Access Compliance Report

Public Rights-of-Way

Intersection ID: 10025976	Main Street: ELM_LN	Cross Street: N/A	Location: NE
ADA ID: 2D33CC14C8C4	Ramp Type: PerpDiag	Initial Pass/Fail: Fail	Overall Compliance: No
Severity Score: 12.5			
Codes/Mitigation Info/Possible Solution		Field Measurements/Component Compliance

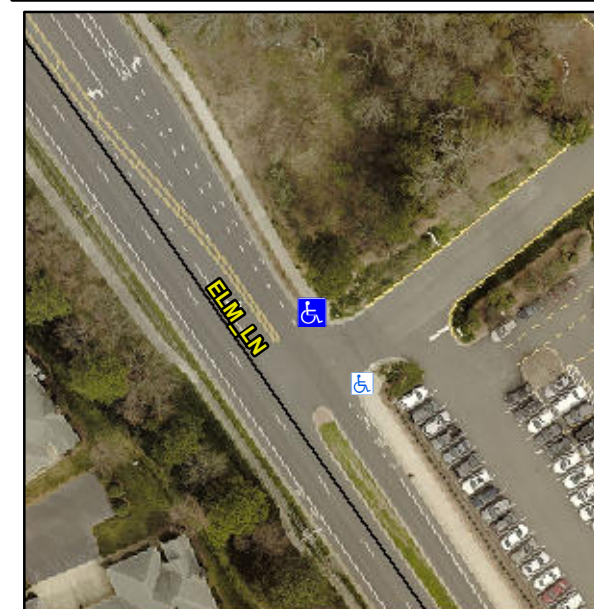
Not Found, R304.2.2

Compliance	Description	Data	Compliance	Description	Data
N/A	Ramp Length (in)	47.0	No	Ramp Slope (%)	11.3
Yes	Ramp Width (in)	48.0	Yes	Ramp XSlope (%)	0.3
N/A	Flare Type LT	N/A	N/A	Flare Type RT	N/A
N/A	Flare Slope LT (%)	N/A	N/A	Flare Slope RT (%)	N/A
N/A	Flare Traversable LT?	N/A	N/A	Flare Traversable RT?	N/A
N/A	Landing Length (in)	N/A	N/A	DWS Provided?	N/A
N/A	Landing Width (in)	N/A	N/A	DWS Contrast?	N/A
N/A	Landing Slope (%)	N/A	N/A	DWS Length (in)	N/A
N/A	Landing X Slope (%)	N/A	N/A	DWS Full Width?	N/A
N/A	Landing Curb? (Y/N)	N/A	N/A	DWS Offset (in)	N/A
N/A	Shared Landing?	N/A			
N/A	Gutter Ponding?	N/A	N/A	Gutter Slope (%)	N/A
N/A	Gutter Lip Ht (in)	N/A	N/A	Gutter X Slope (%)	N/A
N/A	Painted X Walk1?	No	N/A	Painted X Walk2?	No
	X Walk 1 Direction	To SW		X Walk 2 Direction	To SE
N/A	X Walk 1 Width (in)	N/A	N/A	X Walk 2 Width (in)	N/A
	X Walk 1 Slope (%)	1.0		X Walk 2 Slope (%)	1.4
	X Walk 1 X Slope (%)	1.3		X Walk 2 X Slope (%)	1.9

Remove & Replace Curb Ramp With Two New Directional Ramps or Equivalent.
